The Commission has issued the enclosed Amendments Nos. 52, 47 and 24 to Facility Licenses Nos. DPR-33, DPR-52 and DPR-68 for the Browns Ferry Nuclear Plant Units Nos. 1, 2 and 3. These amendments consist of changes to the Technical Specifications in response to your request of January 5, 1979 (TVA BFNP TS 119).

The amendments authorize you to substitute a computational thermal model for in-situ temperature monitoring stations to determine compliance with the mixing zone temperature limits and the State of Alabama water temperature standards.

Amendment No. 52
License No. DPR-33

MONITORING WATER TEMPERATURES IN WHEELER RESERVOIR

Figure 2.1-1
Location of Water Temperature Monitors in Wheeler Reservoir
Browns Ferry Nuclear Plant

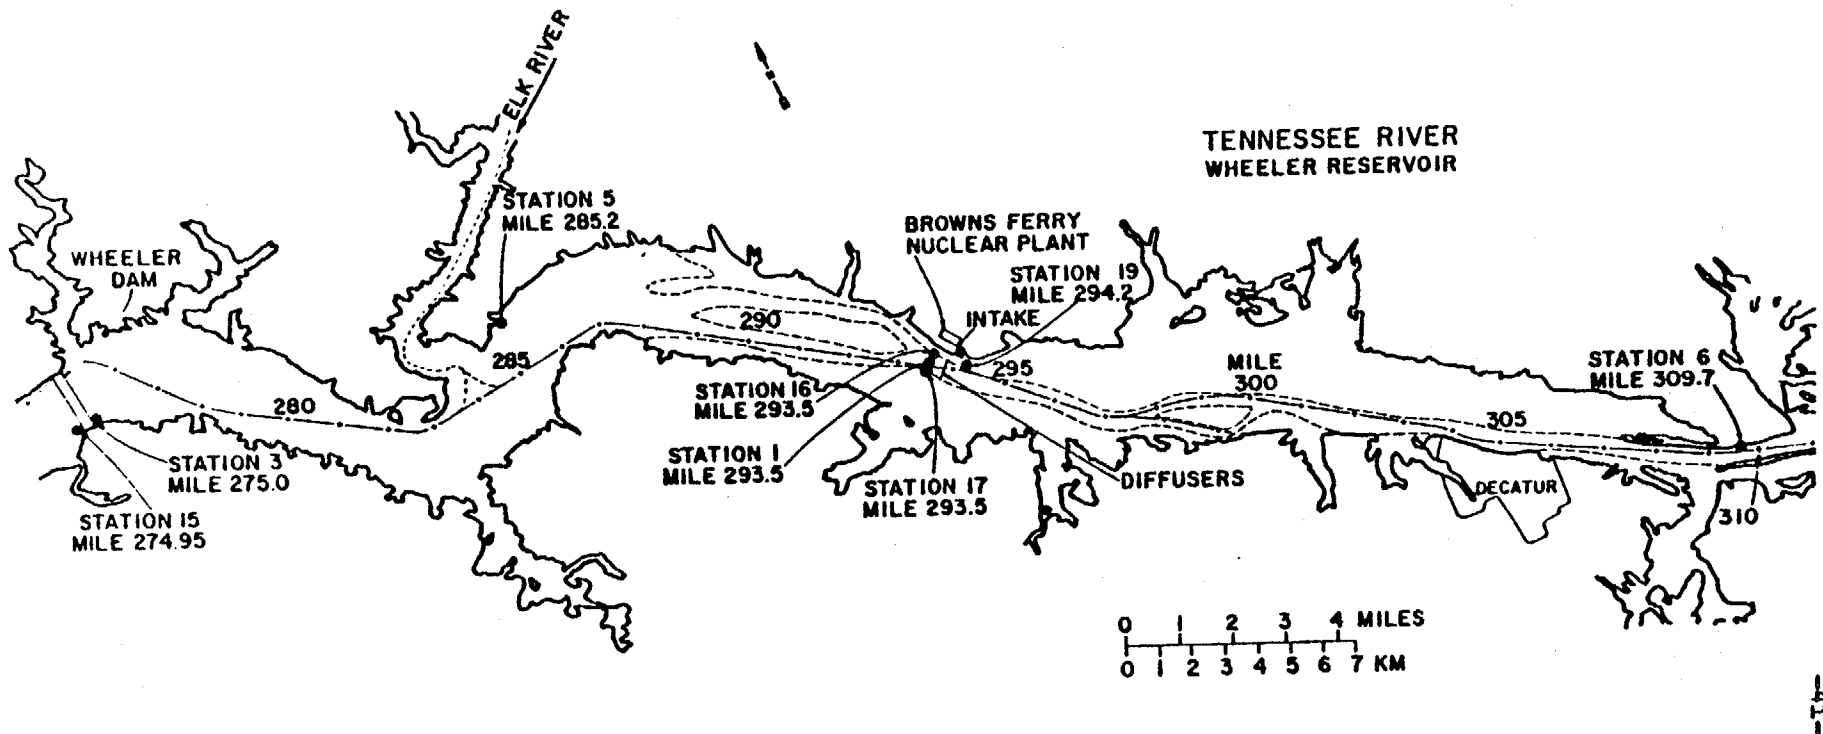
Reservoir water temperatures used to help show compliance with applicable standards will be measured at the one-meter and two-meter depths and averaged to give a temperature applicable to the five-foot depth, which is the point of application of the current Alabama temperature standards. Three thermal monitors spaced across the reservoir in the vicinity of river mile 293.5 shall be used to measure downstream mixed water temperatures. The system is designed so that the downstream monitors serve as backup for one another. The accuracy of the monitoring equipment and the sensitivity of the thermistor sensors are designed to be $\pm 0.3^\circ\text{F}$ and 0.01°F , respectively. The locations of temperature monitors are displayed in Figure 2.1-1.

The plant-induced temperature rise shall be computed using a computer model for the mixing of the plant discharge. This model requires measured plant data as well as downstream reservoir temperatures as inputs and will be updated as necessary to reflect current understanding of discharge mixing predictions.

Figure 2.1-1
Location of Water Temperature Monitors in Wheeler Reservoir
Browns Ferry Nuclear Plant

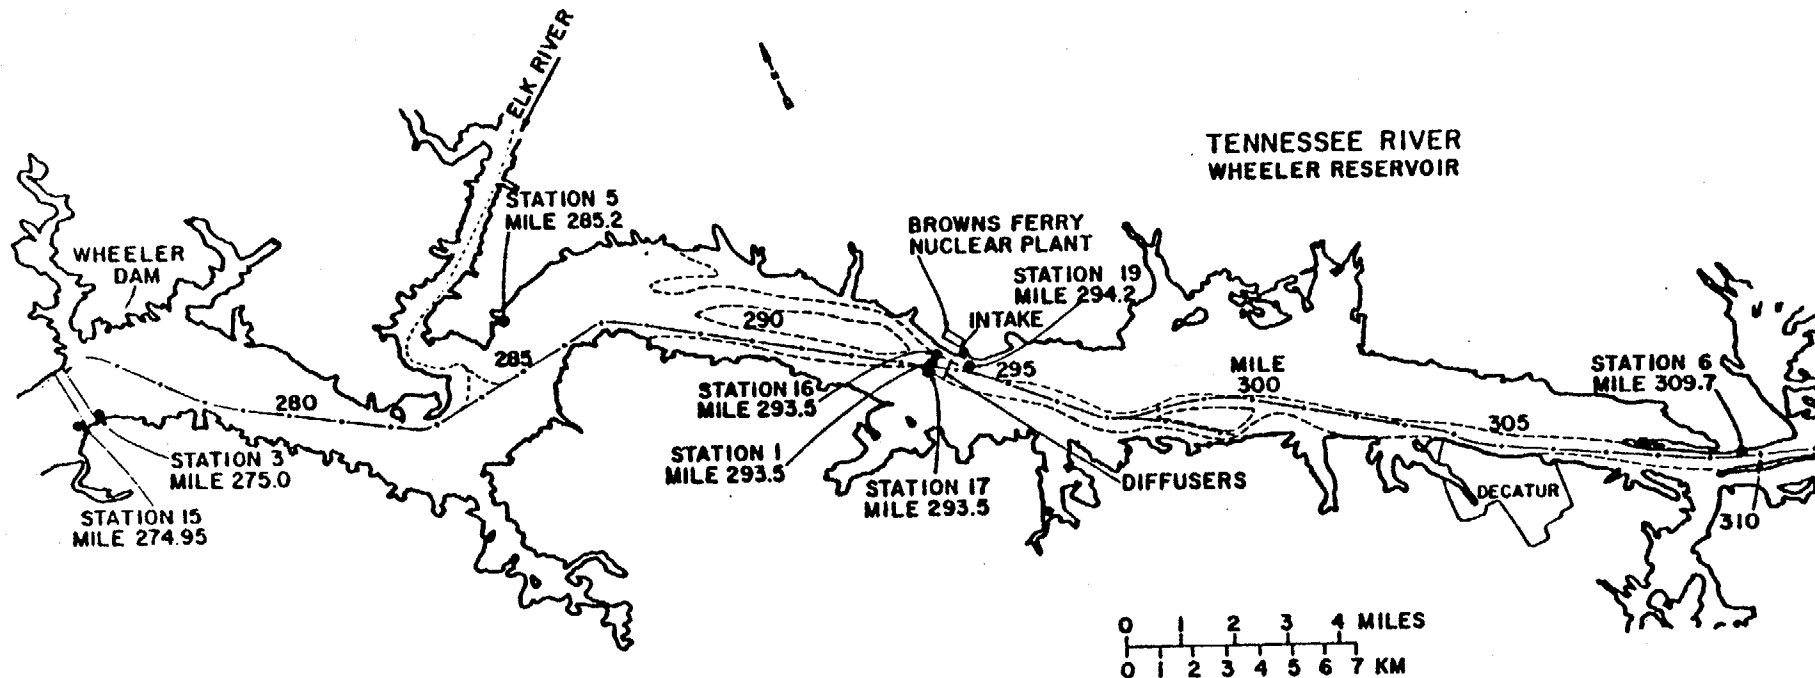
Reservoir water temperatures used to help show compliance with applicable standards will be measured at the one-meter and two-meter depths and averaged to give a temperature applicable to the five-foot depth, which is the point of application of the current Alabama temperature standards. Three thermal monitors spaced across the reservoir in the vicinity of river mile 293.5 shall be used to measure downstream mixed water temperatures. The system is designed so that the downstream monitors serve as backup for one another. The accuracy of the monitoring equipment and the sensitivity of the thermistor sensors are designed to be $\pm 0.3^\circ\text{F}$ and 0.01°F , respectively. The locations of temperature monitors are displayed in Figure 2.1-1.

The plant-induced temperature rise shall be computed using a computer model for the mixing of the plant discharge. This model requires measured plant data as well as downstream reservoir temperatures as inputs and will be updated as necessary to reflect current understanding of discharge mixing predictions.

Figure 2.1-1
Location of Water Temperature Monitors in Wheeler Reservoir
Browns Ferry Nuclear Plant

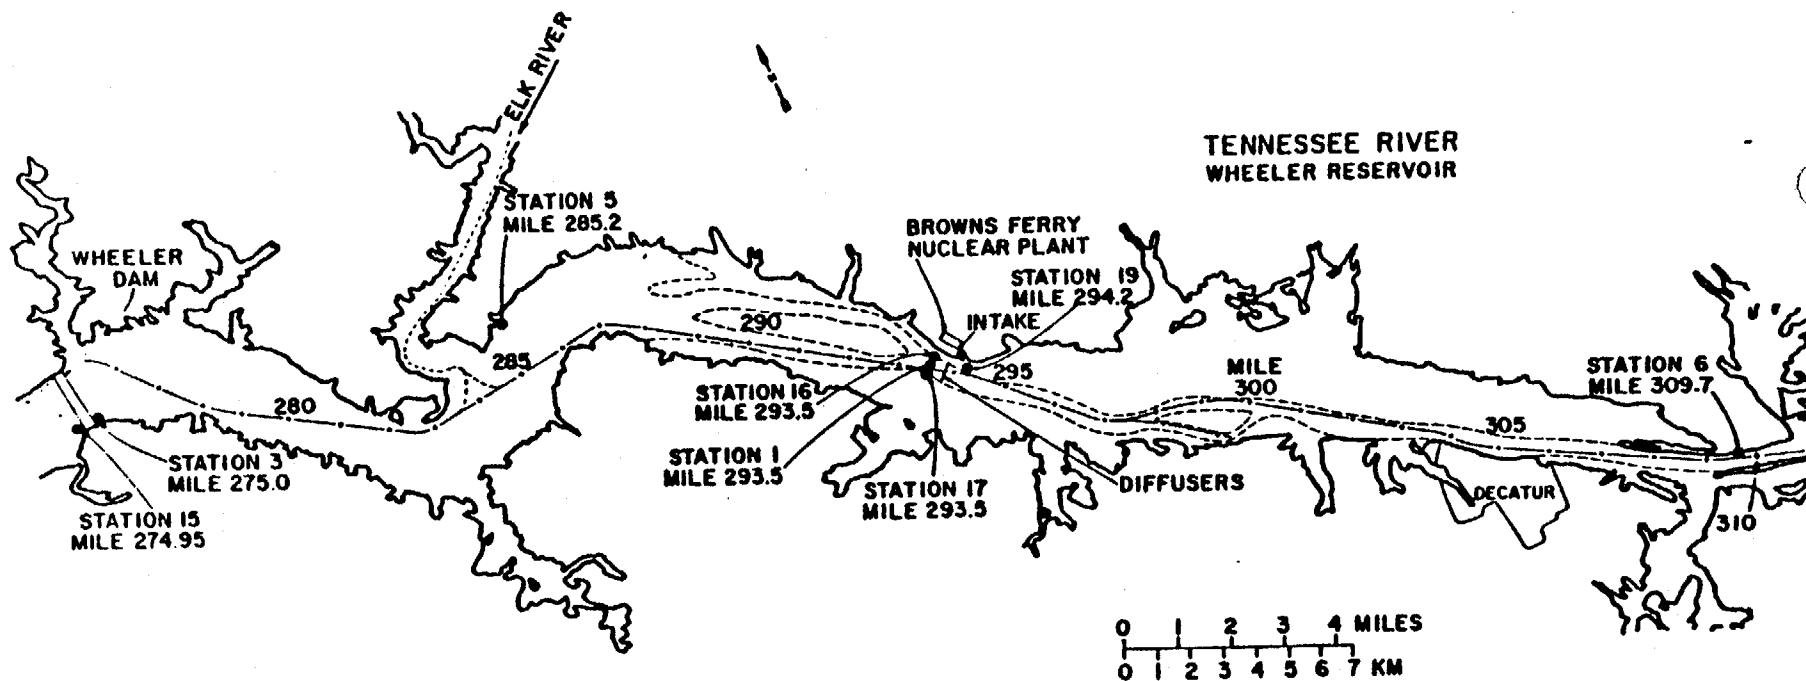
Reservoir water temperatures used to help show compliance with applicable standards will be measured at the one-meter and two-meter depths and averaged to give a temperature applicable to the five-foot depth, which is the point of application of the current Alabama temperature standards. Three thermal monitors spaced across the reservoir in the vicinity of river mile 293.5 shall be used to measure downstream mixed water temperatures. The system is designed so that the downstream monitors serve as backup for one another. The accuracy of the monitoring equipment and the sensitivity of the thermistor sensors are designed to be $\pm 0.3^\circ\text{F}$ and 0.01°F , respectively. The locations of temperature monitors are displayed in Figure 2.1-1.

The plant-induced temperature rise shall be computed using a computer model for the mixing of the plant discharge. This model requires measured plant data as well as downstream reservoir temperatures as inputs and will be updated as necessary to reflect current understanding of discharge mixing predictions.
